REVISED RESPONSE TO REQUEST FOR ADDITIONAL INFORMATION

APR1400 Design Certification

Docket No. 52-046

RAI No.: 222-8203
SRP Section: 11.05 – Process and Effluent Radiological Monitoring Instrumentation and Sampling Systems
Application Section: 11.5
Date of RAI Issued: 09/23/2015

Figure 11.5-2BB Location of Radiation Monitors at Plant (Auxiliary Building El. 137'-6")

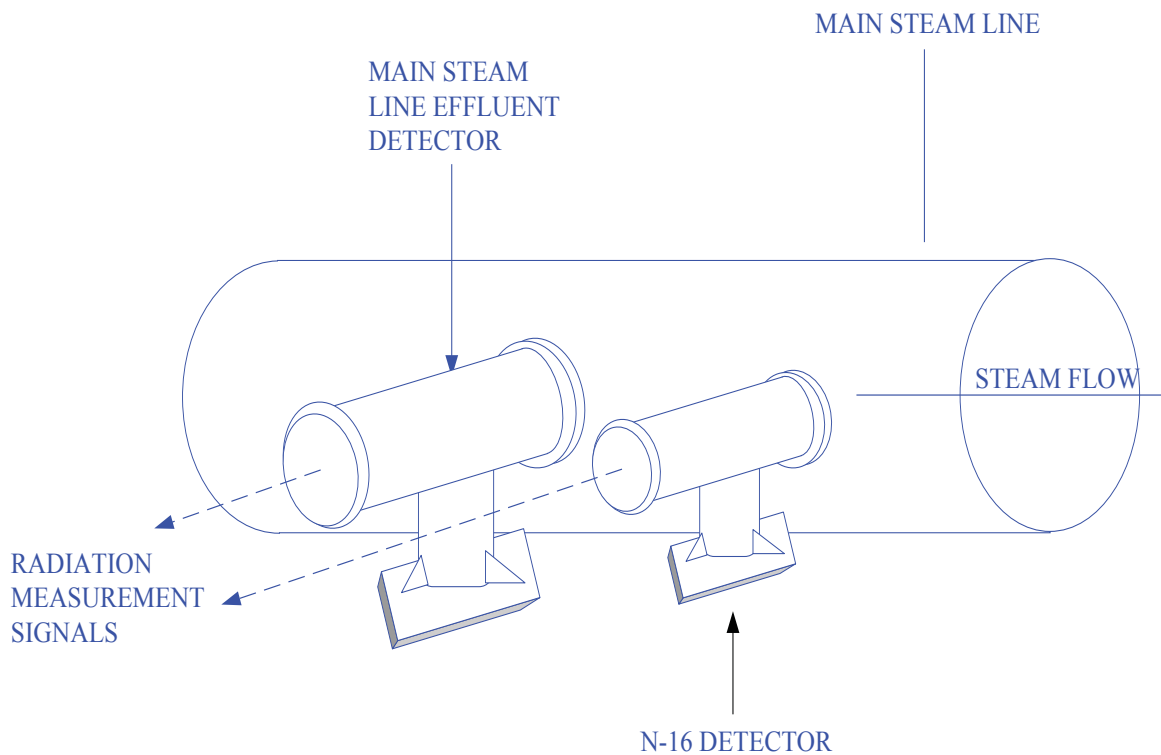
DCD Tier 2 Subsection 11.5.2.2.5.m, Figures 11.5-2K, 11.5-2L, 11.5-2M, 11.5-2BB and Appendix 11B will be updated. Figure 11.5-3C will be added.

The monitors are located in Auxiliary Building as shown in Figure 11.5-2L (RE-217), Figure 11.5-2K (RE-218), Figure 11.5-2BB (RE-219), and Figure 11.5-2M (RE-220).
